CITY OF ALBUQUERQUE

RE: **Lot 3 Block 2 Unit 27, S.A.D. 228**
Volcano Cliffs Subdivision
5500 Valiente Rd. NW
Grading and Drainage Plan
Engineers Stamp Date; 9-10-2020 (C11D008)
Pad Certification Date; 8/27/2021

DRAINAGE AND TRANSPORTATION INFORMATION SHEET (REV 6/2018)

5500 VALIENTE RD NW, ALBUQUERQUE, NM 87120			
CITY OF ALBUQUERQUE, BERNALILLO COUNTY		NEW MEXICO.	
LOT 3, BLOCK 2, UNIT 27 VOLCANO CLIFFS SUBDIVISION			
CANDELARIA HOMES (BEWLEY) - G & D PLAN			
McDowell Engineering, Inc.			
7820 BEVERLY HILLS AVE. NE • ALBUQUERQUE, NM 87122			
TELE: 505-828-2430 • FAX: 505-821-4857			
Designed JSM	Drawn STAFF	Checked JSM	Sheet of
File BEW0121L	Date AUGUST,2021		1 1

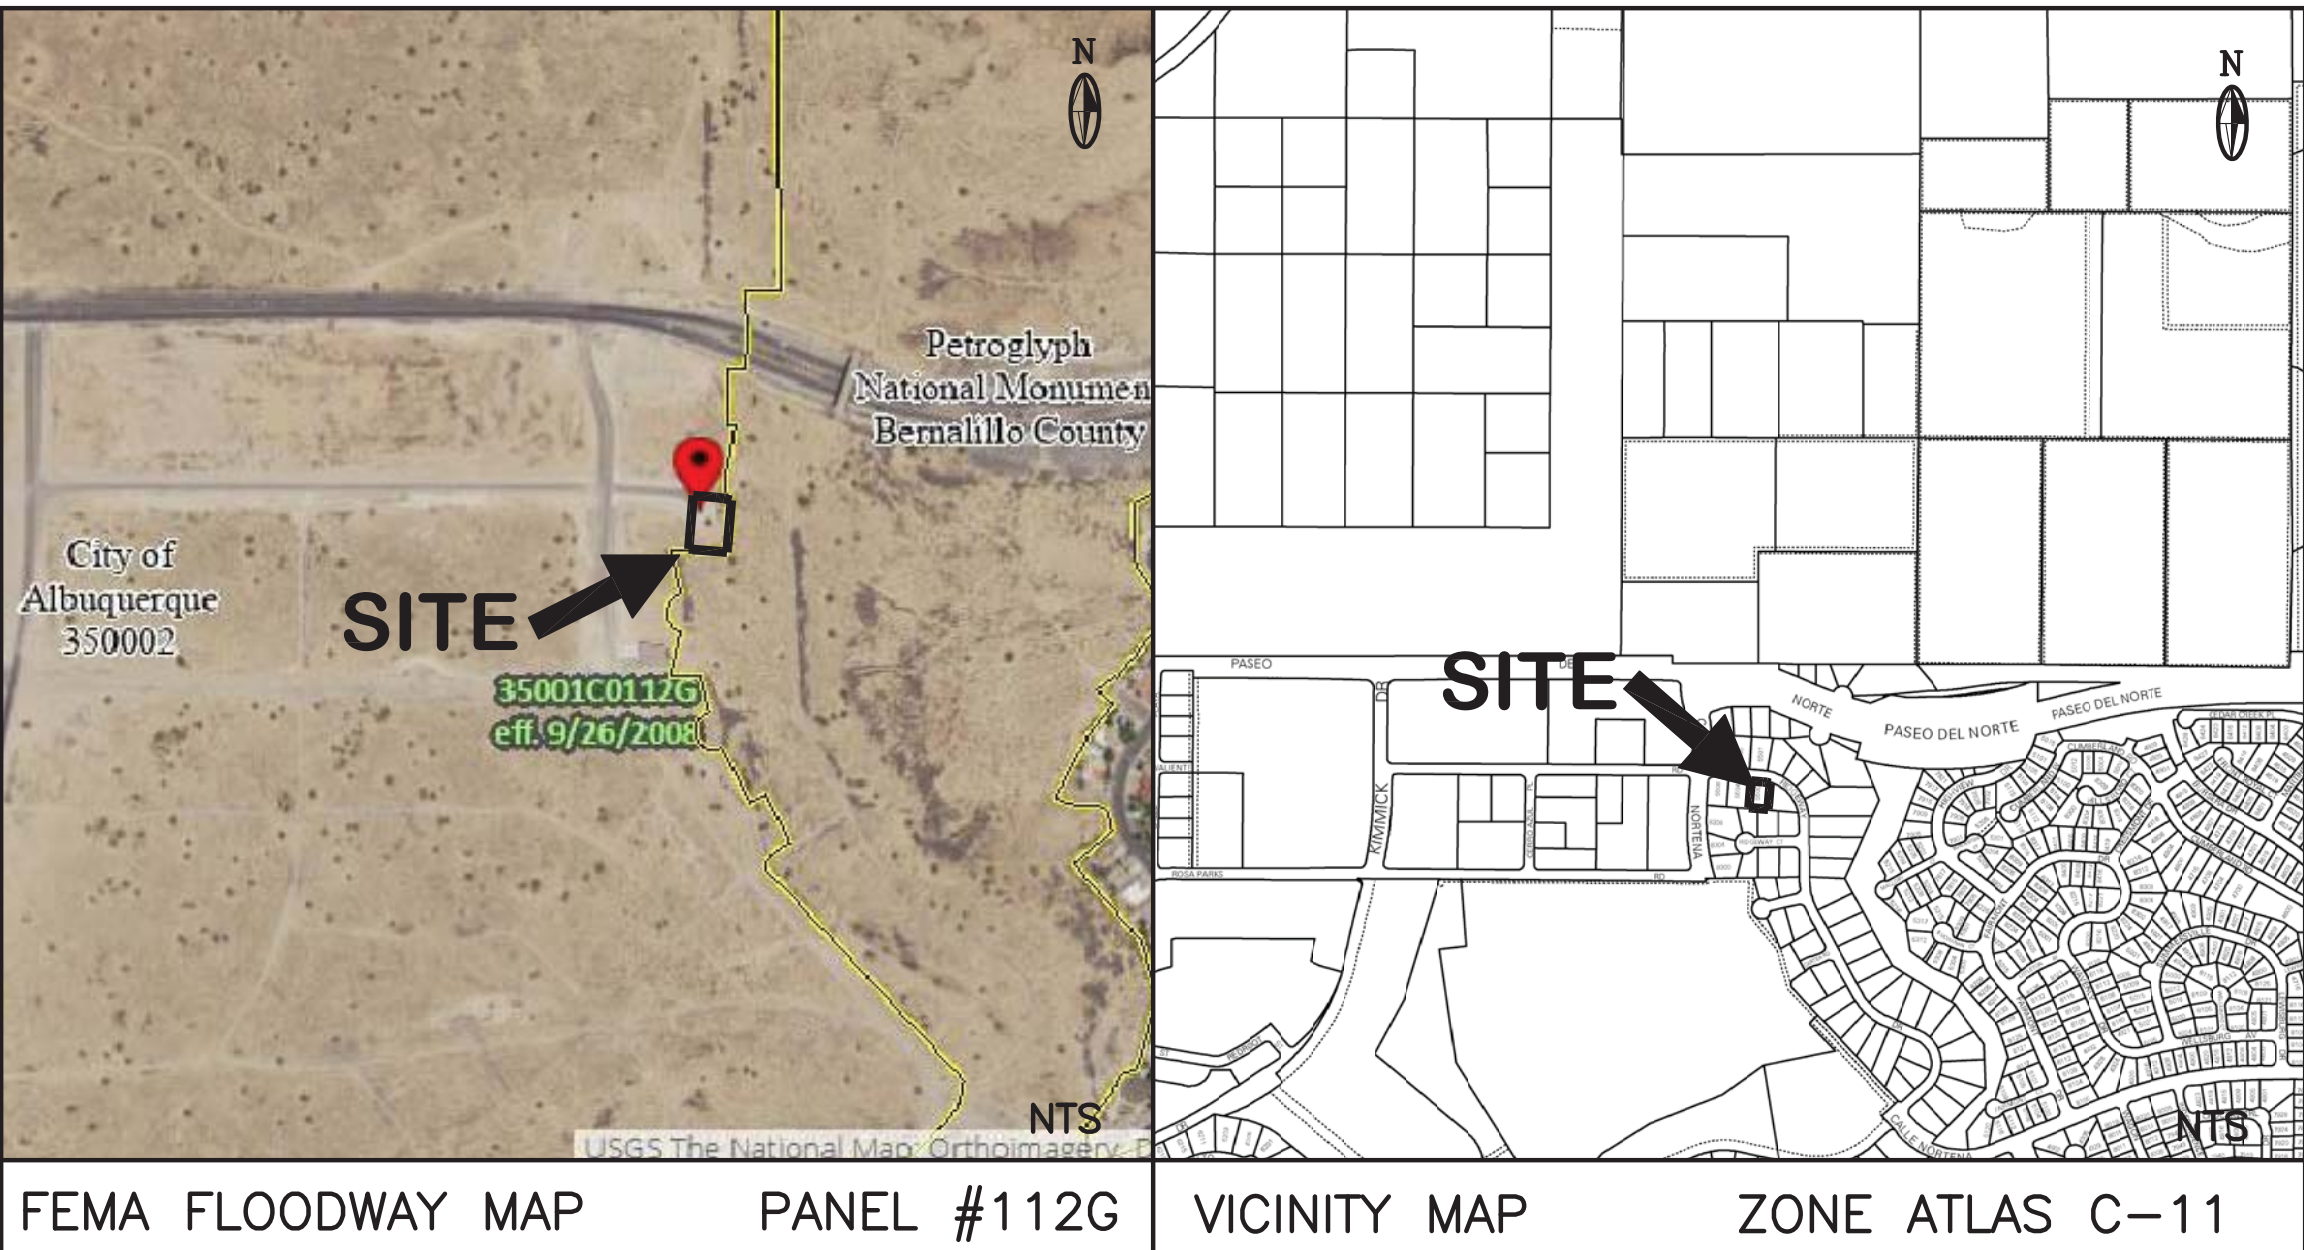
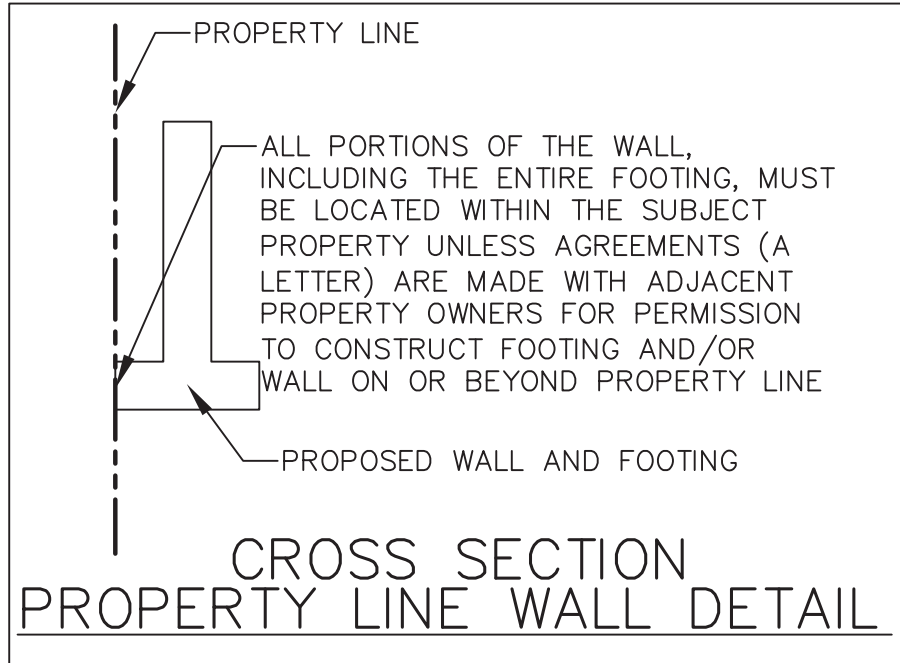
This is the plan to be used for any garden walls and any openings in the walls shall be placed 3" above final grade in the rear yard to allow for cross lot drainage from west to east (upstream to downstream).
